Range H&C HoReCa	Model 9100, 95, Kalea, Kalea Plus, Krea, Karisma, La Radiosa, 9000, Opera Touch (46mm Ø) , G150, Solista, Canto (46mm Ø), Maestro (46mm Ø)	N° T.I. 16_2019
Serial Number 94312015	Subject Z4000 ES-FB, HoReCa and Large strengthen

To strengthen the Z4000 ES-FB, HoReCa and Large models.

Pinion

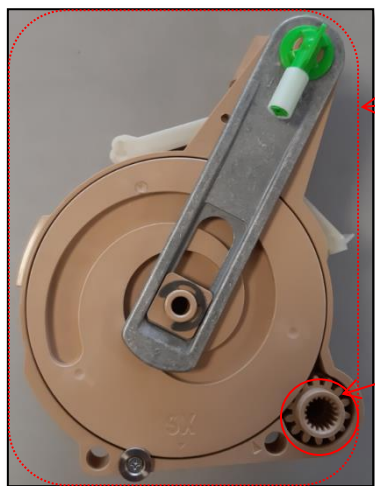
Introduction of a new coffee unit **Pinion** and a **self-tapping screw**.

New Pinion code 262496
sap: 55121561

Old Pinion code 254673

New Pinion

New Self-tapping screw code
sap : 55112829

The modification is **retrofitable** by ordering the spare code **262497** **sap: 55121562**. (the retrofit pack does include 2 pinions + the screw).
